TO: CITY COUNCIL **DATE:** SEPTEMBER 13, 2004
FROM: CITY MANAGER
SUBJECT: PREDEVELOPMENT PLAN REVIEW FOR NEW CONSTRUCTION OF A
RESEARCH/OFFICE BUILDING AT 686-700 SOUTH RAYMOND
AVENUE

PPR2004-00019 *Council District 6*

Attachment C
PPR Comments from City Staff

PROPOSED SITE PLAN MAY 12, 2004

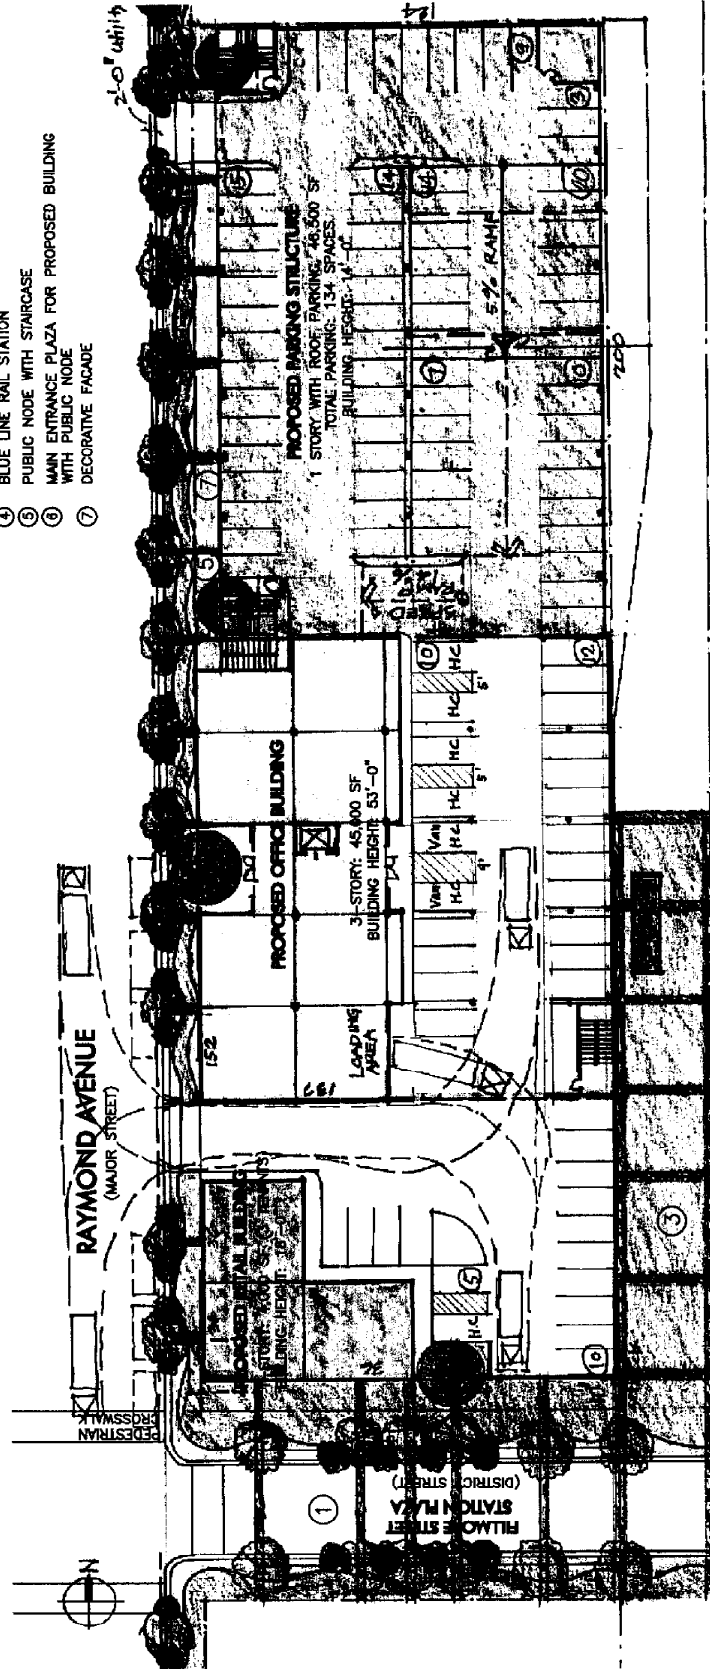
It is not clear on the preliminary plans if this requirement is being met. Before the project is submitted for Design Review, make sure that Current Planning has verified the location and square footage proposed for the open space requirement.

Based to the information provided on the plans, the number of loading spaces is not in compliance with the number required per code. Revise the plans to comply with the loading space requirements.

Site Design: At the south-east corner of the site, along Fillmore Street, the absence of retail space, landscaping, and other amenities “inviting to pedestrians” should be restudied. The proposal for surface parking abutting a stretch of Fillmore Street is inconsistent with the emphasis throughout the specific plan on activating the streetscape in this location. One alternative might be to introduce a linkage of some kind similar to the glazed bridge between the office building and the parking structure. Another approach might be to add enhanced landscaping and other pedestrian-friendly features to the short frontage on Fillmore Street. Along Raymond Avenue, the street-facing edge of the parking structure also requires special attention; features that add pedestrian interest—such as color, landscape, and texture—should be proposed for this important elevation. The recommended treatments for walls in the specific plan (pp. 48-49) might be helpful to develop an appropriate design for the base of the parking structure.

four of the trees (oaks; bottle brush) are subject to the tree protection ordinance. The oak tree appears to be in the location of the public node off Raymond Avenue; in that event, this tree—if healthy and aesthetically suitable—should be retained for use in this location. Possibly the palm trees affected by new construction could be relocated and integrated into a new landscape design. The edge of the site along the light rail tracks may also be an opportunity for creative landscaping.

PROPOSED ELEVATION FROM S. RAYMOND AVENUE MAY 27, 2004
 MIXED USE DEVELOPMENT | ALEXANDRIA REAL ESTATE EQUITIES | 686-700 S. RAYMOND AVENUE, PASADENA, CA 91105-3253

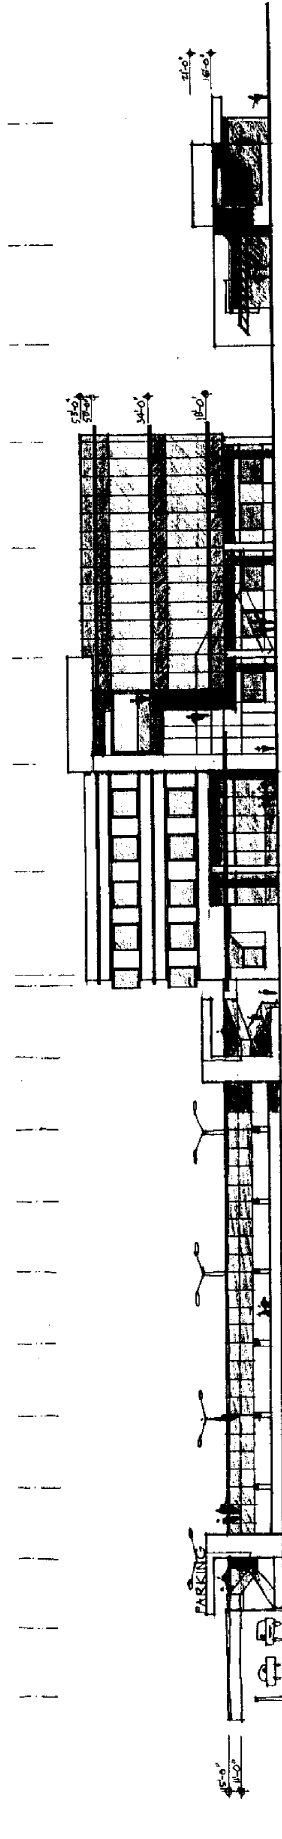
Based on the preliminary building elevations, the proposed retail building is 21 feet in height, and the office building is approximately 53 feet in height with an additional appurtenance over 53 feet. It appears that the appurtenance is in compliance with the height requirements, but the city needs a scaled set of building elevations to verify the height requirements.

Building Elevations: The multifaceted composition of the primary building follows the direction in the specific plan to use volume, massing, materials, and proportion and scale to express activities and functions. The juxtaposition of glass-curtain walls with a large cantilevered centerpiece and five bays of projecting windows is challenging for a building with a relatively small footprint. The synthesis of these features will be a major consideration during design review. The commitment to employ protruding window assemblies with strong geometries is commendable. This infusion of innovative design to this area presents an opportunity to support a burgeoning “community of interest and identifiable district image” with “visual vitality” to South Raymond Avenue [p. 11, specific plan]. The roofline of the building should be designed to conceal roof-top mechanical equipment (or to otherwise organize roof-top appurtenances as part of the architectural organization of the building) [p. 57, specific plan]. The design guidelines for the specific plan encourage cornice lines on new buildings [p. 19].
